SUBJECT: SAFETY EVALUATION REVIEW OF THE SOG/EPRI TOPICAL REPORT TITLED
"SEISMIC HAZARD METHODOLOGY FOR THE CENTRAL AND EASTERN UNITED
STATES", EPRI NP 4726

Subject: Safety Evaluation Review: SOG Topical Report,
"Seismic Hazard Methodology for the Central and
Eastern United States."

Figure V.A Sample of feature assessment form that each team filled out for each feature for estimating the probability that a feature is active (seismogenic).

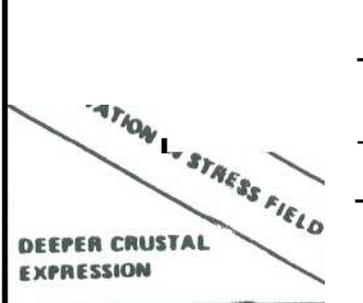
The methodology requires the teams to enter in the feature characteristic matrices estimates of probabilities that features **having various** characteristics are active. Such estimates are necessarily subjective. The use of subjective probabilities in the EPRI/SOG methodology was discussed in detail by Dr. David Brillinger (1985): Dr. Brillinger noted: "The problems of projecting earthquake activity and strength and of then extrapolating to effects at given sites are very difficult ones. There is little data (and what is available is biased), there is high variability, there is only moderate physical knowledge concerning the causative processes involved and there is an inability to perform substantial experiments." He further stated "The EPRI/SOG study makes essential **use** of personalistic probabilities. I suggest that these probabilities are without significance unless they can be meaningfully related to the external world. Some empirical validity is needed. That the Earth Science Teams were willing to guess values is surely not all that is needed to justify the use of those values" (Brillinger, 1985, p.10).

Figure X.A

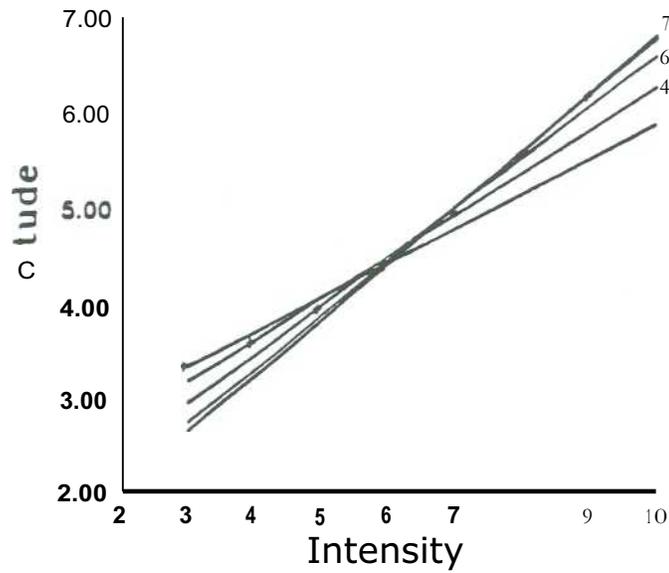
Figure X.A reproduced from Bender (1987) illustrates the different lines $mb = a + bI_0$ that may result for the same set of earthquakes when different ranges of I_0 values are used to fit the lines. It is assumed the I_0 values contain errors and a fraction of the earthquakes with low intensity values are missing from the data set. Figure X.A illustrates that 'missing' earthquakes affect the values of the fitted coefficients even if the missing earthquakes are outside the range of magnitudes used to fit the coefficients. Similarly, Table X.A. illustrates the range of a and b values in the relationship $mb = a + bI_0$ that may result when intensities in various ranges are used to fit the coefficients. Results shown are for two models in which the maximum magnitude is infinite and one model in which the maximum magnitude is 7.3. A friction of lower magnitude earthquakes is missing in each case, and no earthquakes with magnitude $mb < 2.7$ have been recorded. The true slope of the line is 0.6, but the fitted slope may be as low as 0.36 if low intensities are used in the fit. The true a is 1.54, and in the doubly infinite model, the expected value of the fitted $a = 0.82$. The correction to obtain mb is based on the assumption that $a = 0.82$. However, we observe that a may be greater than 2.2, and is never a small 0.82. Thus, the correction may never be applicable to real data.
